Structural Special Inspections Report

Maine Eye Retina & Surgery Center

Portland, Maine
December 22, 2016

Structural Engineer of Record
Becker Structural Engineers, Inc.
75 York Street
Portland, ME 04101
207. 879. 1838

Photo 1: Exposed, Field-Cut Reinf in Structural Slab

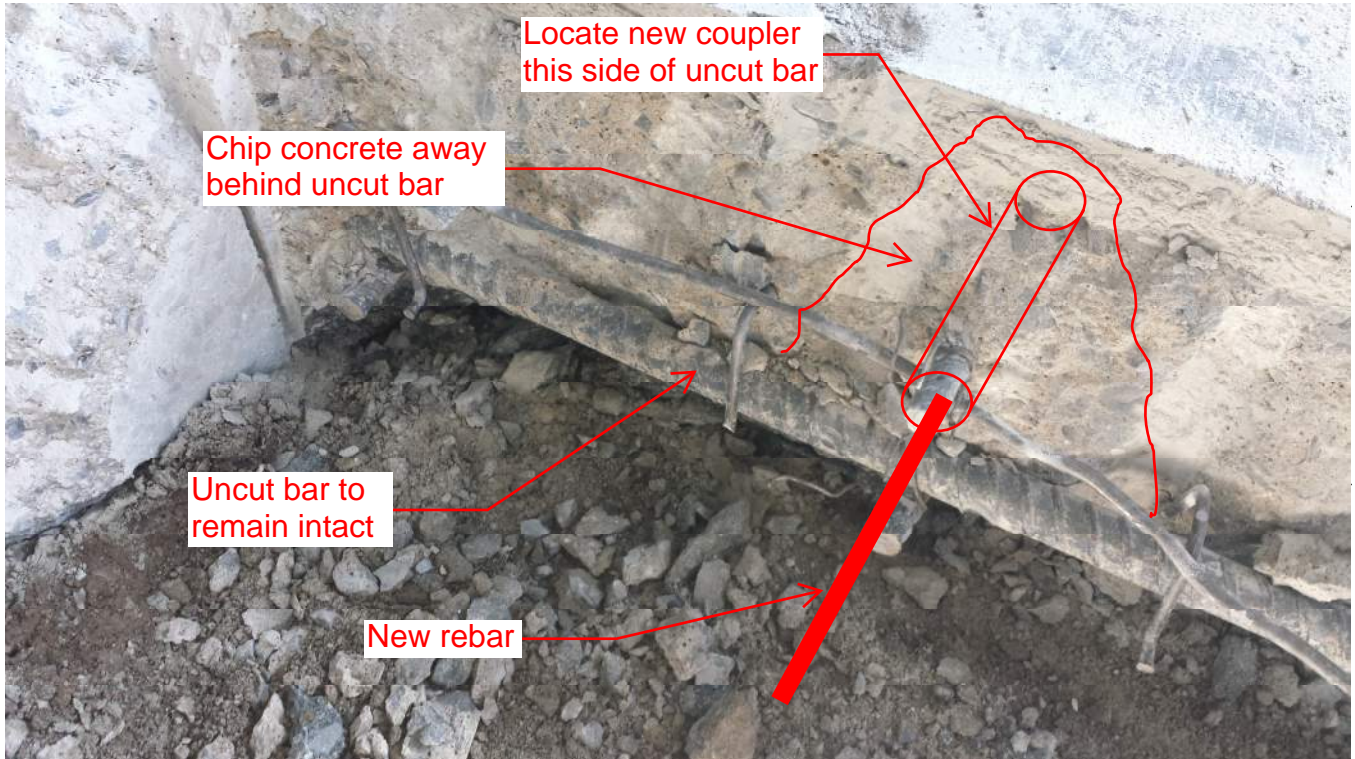
Concrete and reinforcement had been fully removed at the (5) locations that were previously marked for slab demolition. Bar sizes in the slab ranged from #4 to #8. Sample rebar couplers were made available by the GC to observe fitup. In most locations, chipping with a hammer will be required in order to expose the ends of the existing rebar so that the new couplers can be slid on. There are some isolated locations where the layout of the bars in each direction will interfere with the coupler (see attached photo 1). At these conditions, the GC was instructed to chip behind the uncut piece of rebar, leaving the uncut bar intact. The couplers shall then be spliced between

the uncut bar and the edge of the slab. Work on exposing the existing bars for the new couplers was ongoing. We will visit the site in the near future to observe the couplers prior to slab placement.

Figure 1: Slab Cut Locations for New MEP Installation

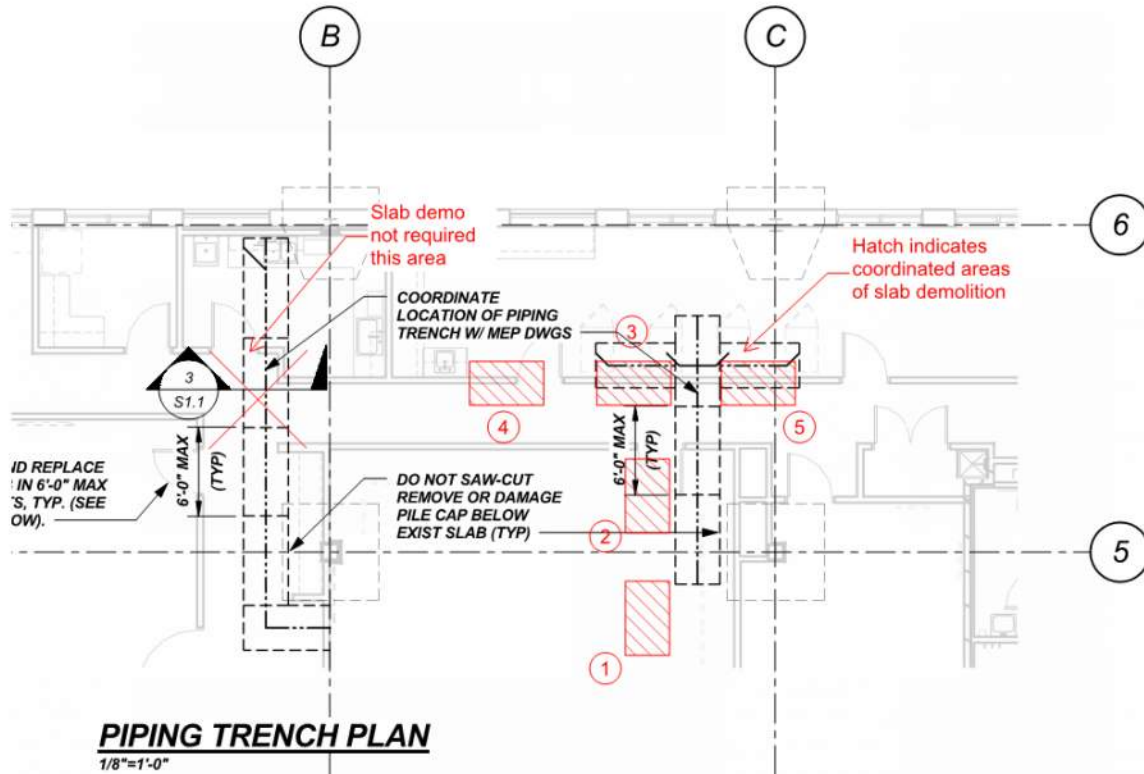
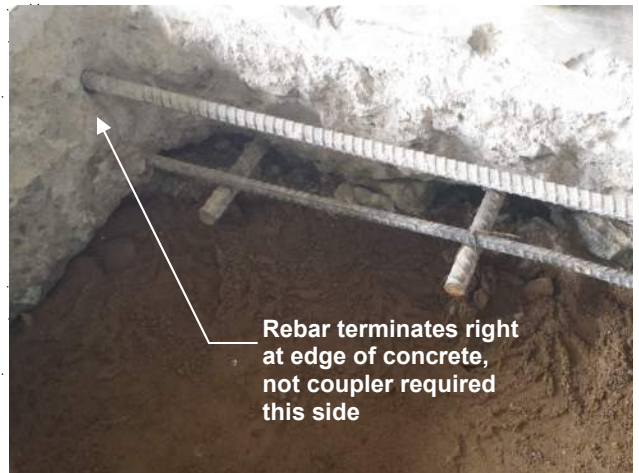
In openings 1 and 2 (see Figure 1), most of the couplers can be installed without any interferences. In some locations where existing bars cross each other in perpendicular directions, one of the bars must be bent upward to fit the new coupler. This occurred in both opening 1 and opening 2, and is shown in Photo 1. The GC was instructed to bend the bottom bar upward so that the couplers could be slid into place. We'll inspect this work during a future visit.

In opening 2, I observed that the top bars that run parallel to the B-line do not continue through the entire opening. They instead terminate right at the edge of the opening (see photo 2). Therefore, the couplers are not needed at this specific location. The GC was made aware of this, and we will inspect the final work during a future visit.

In opening 3, a floor drain near the center of the opening interfered with one of the bottom bars running parallel to 6 line. The GC was instructed to terminate the new reinforcement at each face of the drain, and then provide an additional full-length bar adjacent to it (see photo 3). We will inspect this work during a future visit.

Opening 4 had no interferences, except that some of the bottom bars need to be bent upward to fit the new couplers. This is similar to the condition described for openings 1 and 2. We will inspect this work during a future visit.

In opening 5, one the new drains interfered with a coupler and prevented it from being installed. The MEP installer looked at this condition and determined the drain pipe could be moved to avoid the interference. This work began while I was on site. Also in opening 5, at the end closest to C-line, I observed double the amount of bottom reinforcement as the opposite end. It was then realized that the opening was cut through a series of rebar lap splices. Since it's the bottom reinforcement in an area of negative bending, the rebar is not in tension. Therefore, the additional bars do not need to be lapped through the length of the opening. The GC was made aware of this. Couplers will be provided at one end of the opening only, and we will observe this work during a future visit to the site.

At the other openings throughout the building, two issues were noted. Bottom reinforcement in one of the openings was cut around a new drain and cannot be replaced (see photo 4). We analyzed the slab with this one rebar omitted, and determined that the overall slab capacity was not compromised, and no further corrective action is required. The other issue was the that several slab cuts where done to create re-entrant corners, which can cause future cracking in the new slab repair (see photo 5). The GC was instructed to make additional cuts in the slab to avoid the re-entrant corners. This work will be inspected during future visits to the site.

Figure 1: Slab Cut Locations for New MEP Installation

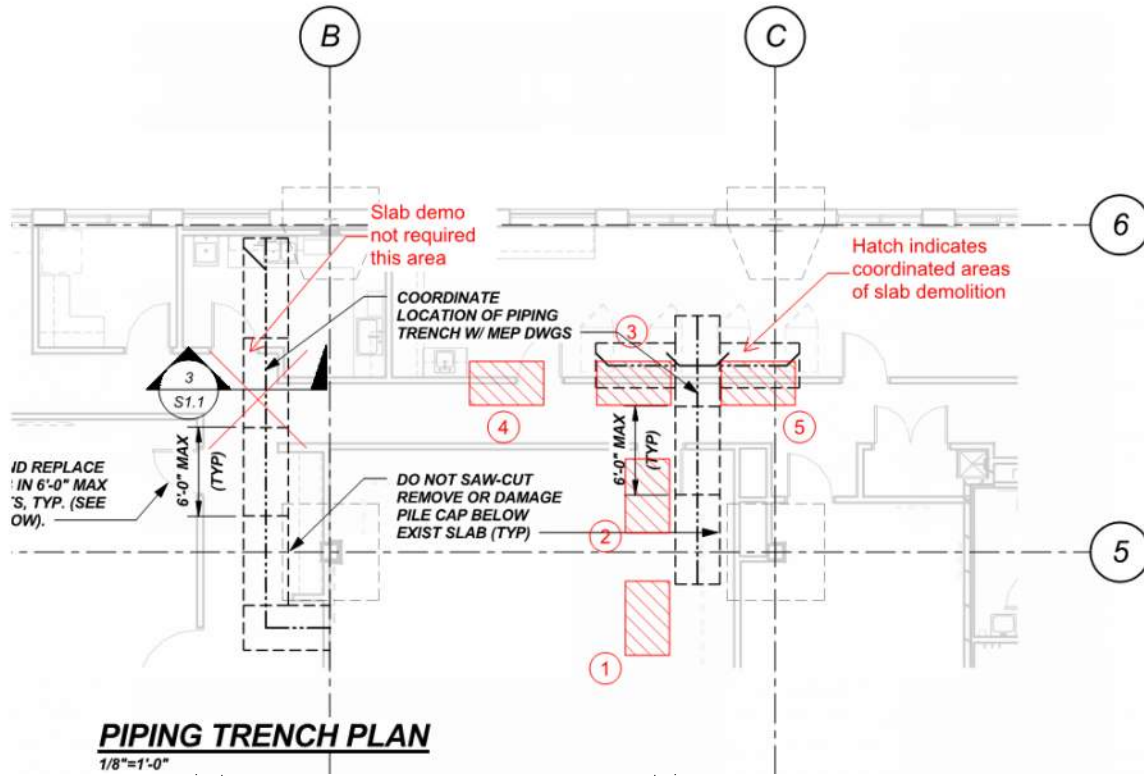
The reinforcement in the exterior pad was observed to be in conformance with the structural drawings. During my visit, I also observed the coupler and reinforcement installation in openings 1 and 2 in the ground floor slab (see figure 1, and photos 1 and 2). The reinforcement and couplers were installed per the structural drawings and per the requirements identified in the Concrete Report on 8/15. The GC was instructed to place concrete in these two openings only. Reinforcement work within openings 3,4 and 5 is ongoing, and we will inspect this during future visits to the site.

Figure 1: Slab Cut Locations for New MEP Installation

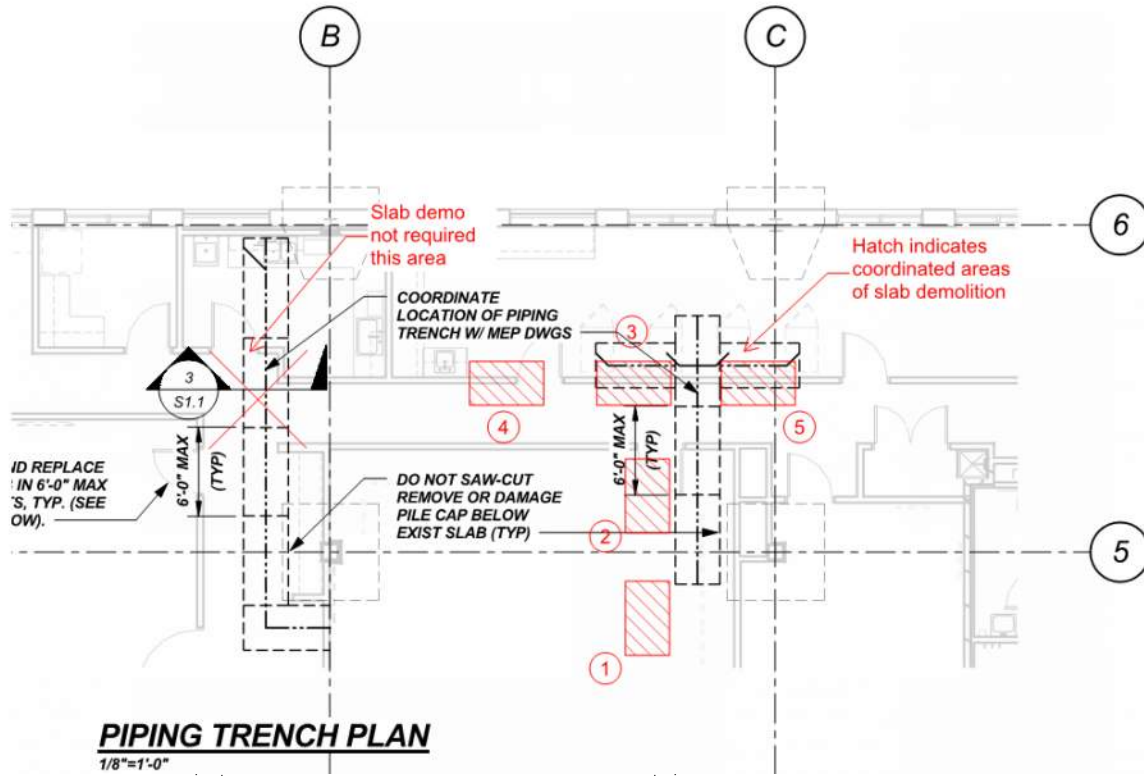
During my visit, I observed the coupler and reinforcement installation in openings 3, 4 and 5 in the ground floor slab (see figure 1). Reinforcement in openings 1 and 2 were inspected on 8/16 (refer to 8/16 report for additional information). The reinforcement and couplers were installed per the structural drawings and per the requirements identified in the Concrete Report on 8/15. In openings 3 and 5, the GC was asked to provide corner dowels around the drains to avoid cracking at reentrant corners. The corner bars were installed and are shown in photos 1 and 2. No additional work is required at this time, and the GC was allowed to place concrete in openings 3, 4 and 5.

Figure 1
 Maine Eye Retina & Surgery Center
 Portland, Maine
 RWG&A No.: 0435-013

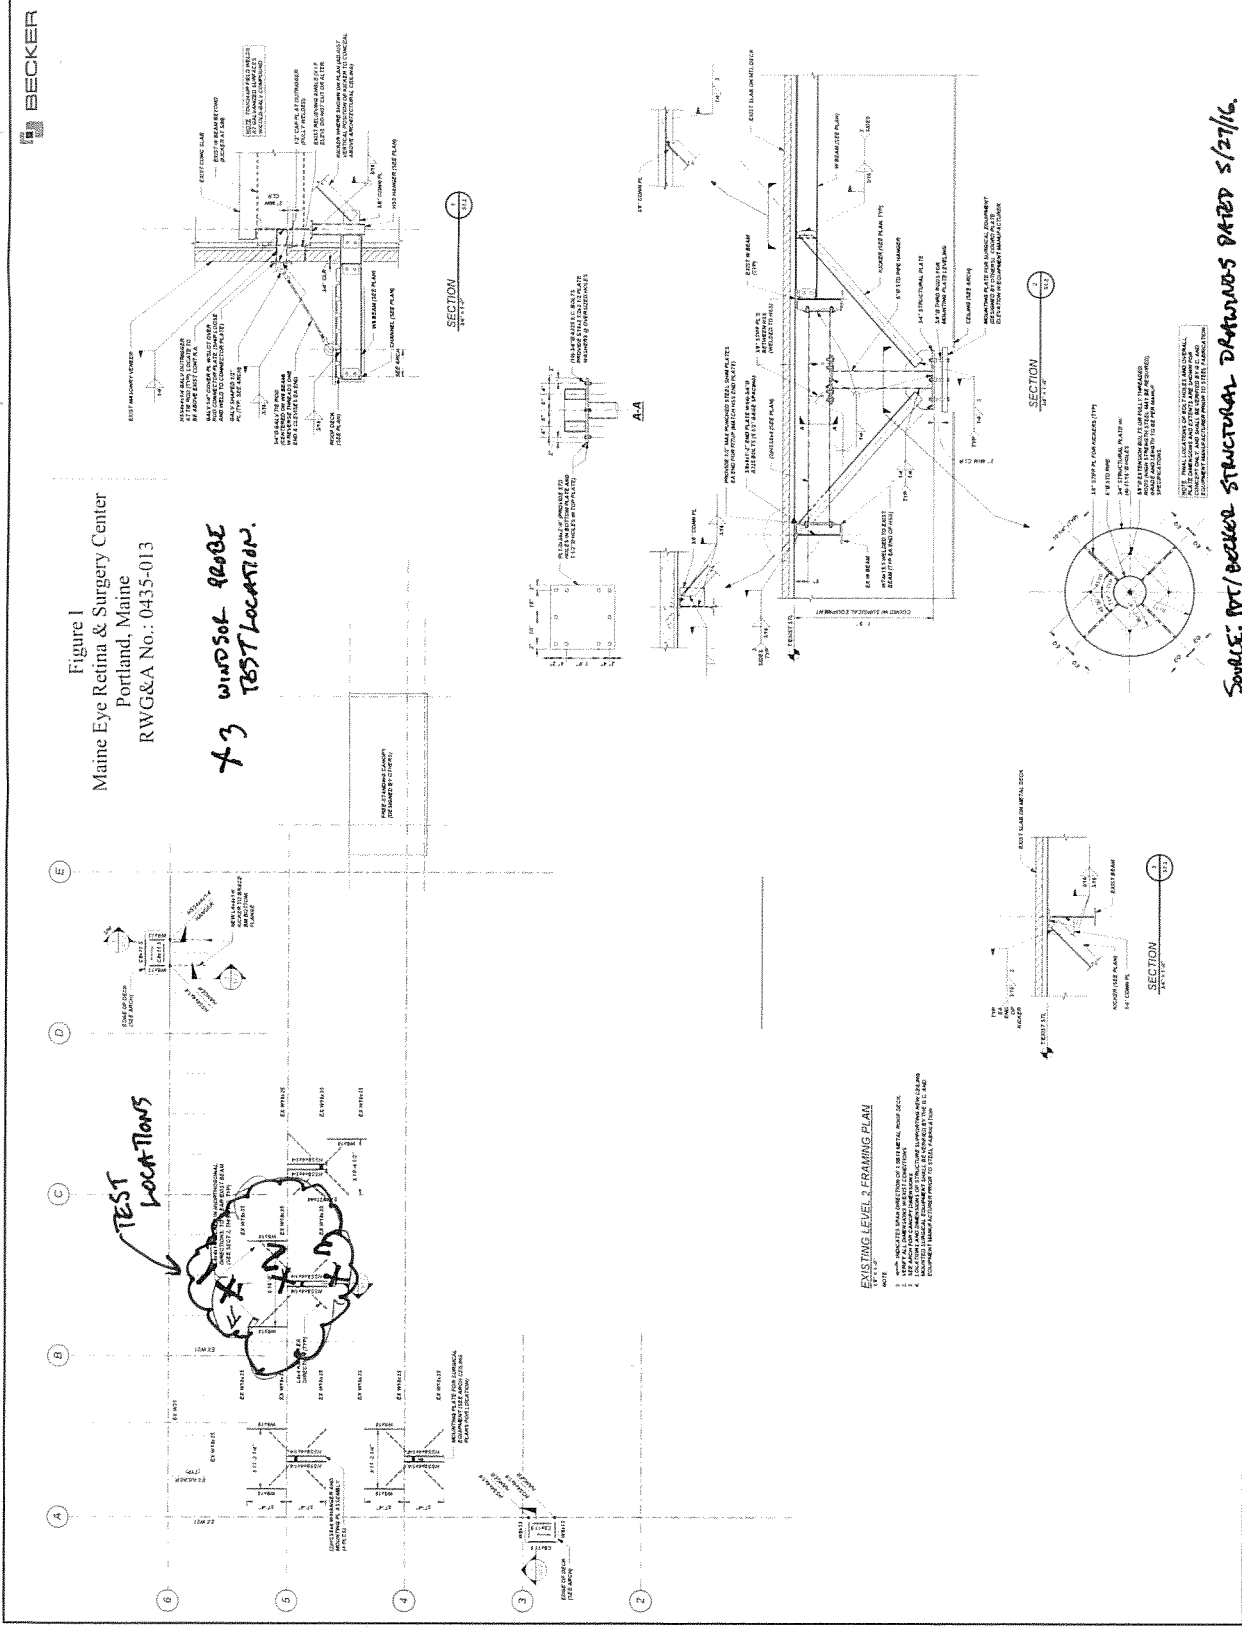
RWG&A uses the Model CT-460A Windsor Probe System in accordance with *ASTM C 803 Standard Test Method for Penetration Resistance of Hardened Concrete*. Windsor probe testing was performed at three locations of the slab infills as indicated in Figure 1. At each location, three steel probes were driven into the concrete with a high-energy, power actuated driver. A depth gauge with a reference plate was used to measure the average depth of penetration of the three probes. Test results are summarized in Table I below.

SKETCH
BACKFILL SEQUENCE
NOT TO SCALE

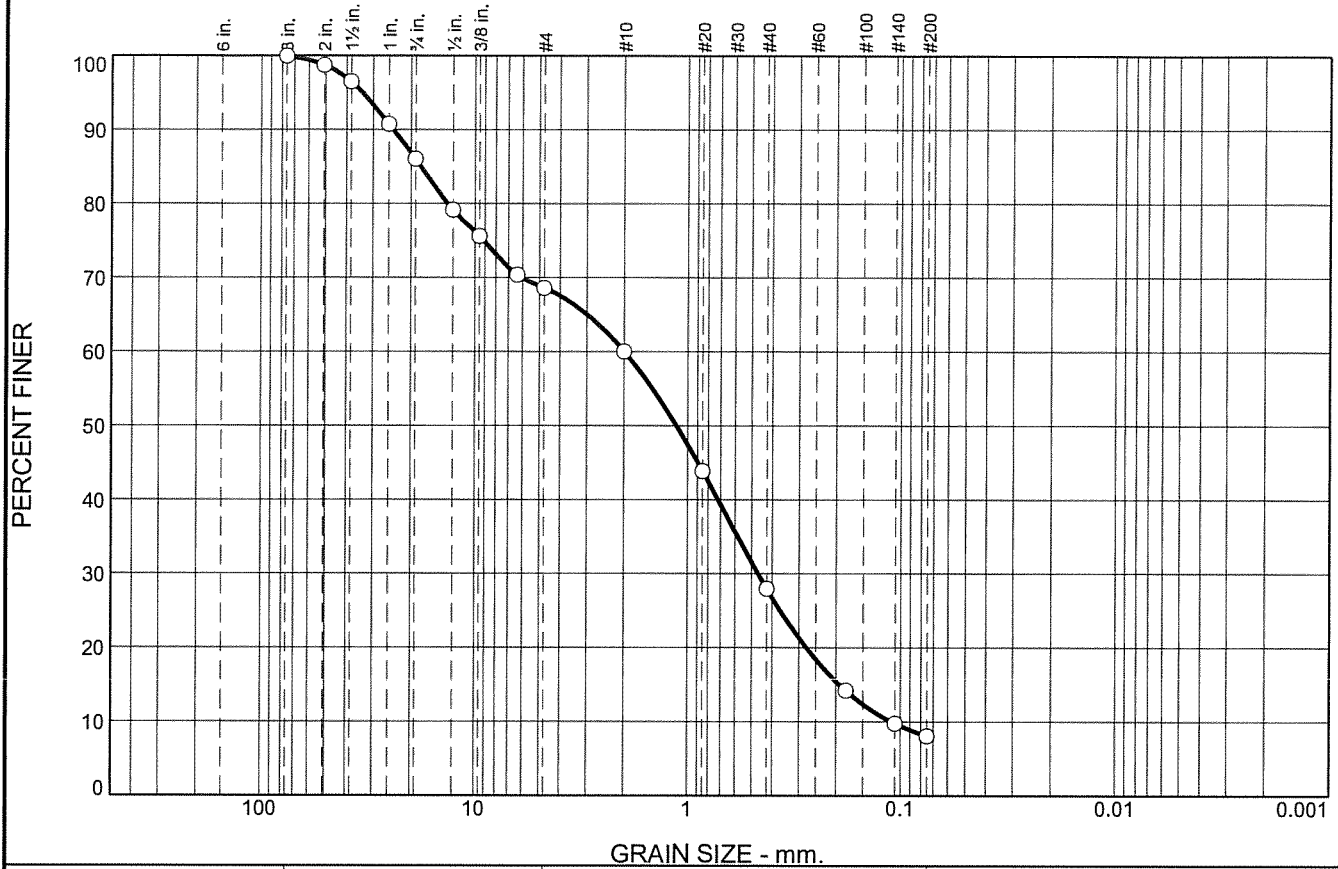
In addition to subgrade compaction, RWG&A recommends that existing fill below the plan limits of the proposed canopy be removed down to footing subgrade level and backfilled with layers of compacted crushed stone wrapped in a geotextile filter fabric, and compacted structural fill. The attached Sketch indicates the backfilling sequence. Existing fill within the interior of the foundation excavation was removed during the site visit.

The on-site aggregate base is suitable for use as structural fill. Structural fill needs to be compacted to at least 95 percent of the maximum dry density as determined by *ASTM Standard D 1557 Test Method for Laboratory Compaction Characteristics of Soil Using Modified Effort (56,000 ft-lbf/ft³ (2,700 kN-m/m³))*.
